#### REMARKS/ARGUMENTS

Appl. No. 10/650,504  
Amdt. Dated December 20, 2005  
Reply to Office Action of September 26, 2005

**Amendments to the Drawings:**

FIG. 9a

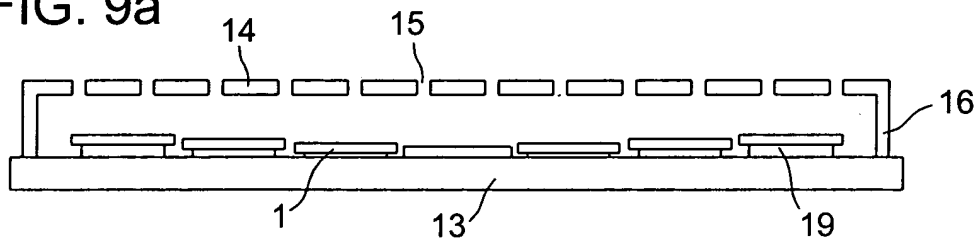
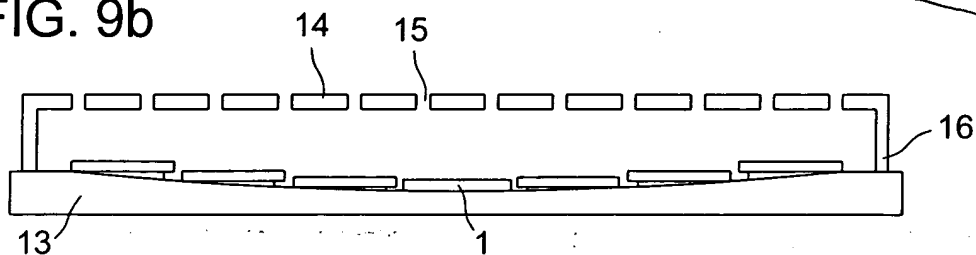
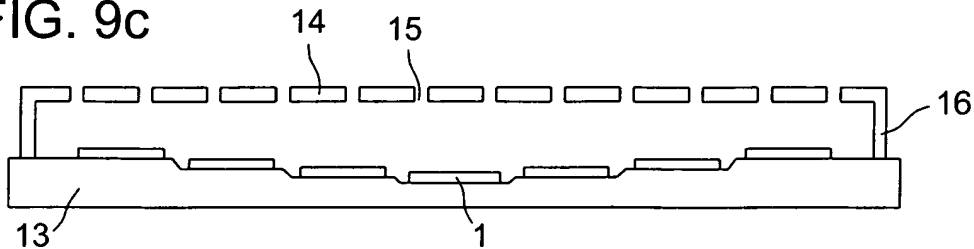
The drawings stand objected to under 37 CFR 1.83(a) as failing to show every feature of the invention specified in the claims. The Office states that the concave substrate-placing surface of the tray must be shown.

In response, Applicant has amended Fig. 9 and replaced it with Fig. 9a, Fig. 9b, and Fig. 9c, which show the concave substrate placing surface of the tray. No new matter has been added. A description of the concave substrate-placing surface of the tray 13 can be found in the Applicant's specification at p. 20 lines 13-21. It would be ordinary and clear to one skilled in the art that Fig. 9a, Fig. 9b, and Fig. 9c meet the technical specification found therein.

The attached sheet of drawings includes changes to Figures 9a, 9b, and 9c.
